Change Notice

PCN No: 128

Notice Type: Product Revision Change

Product Type: SL162

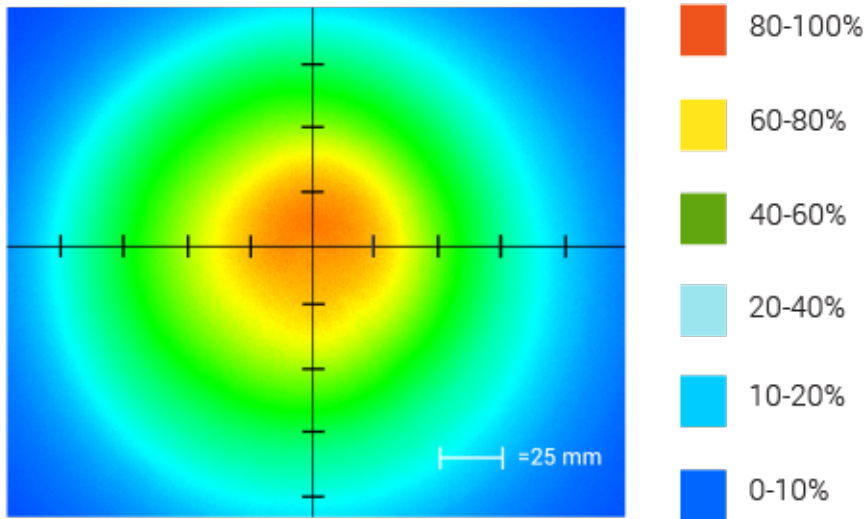
In an effort to improve our products, Advanced illumination (Ai) will update the LEDs used in the SL162 design. This change will result in a brighter, more uniform light at the same price*. Customers may still buy the current revision of this model until July 15th of 2016. After that time, orders for these products will be converted to their respective SL162 Revision A models.

This LED change will result in additional wavelengths being available: 365nm, 375nm, 385nm, 395nm, 405nm, 455nm, 470nm, 505nm, 530nm, 590nm, 625nm, 660nm, 730nm, 850nm and 940nm. Additionally the white LED color temperature will be changing from 6100K to 5500K.
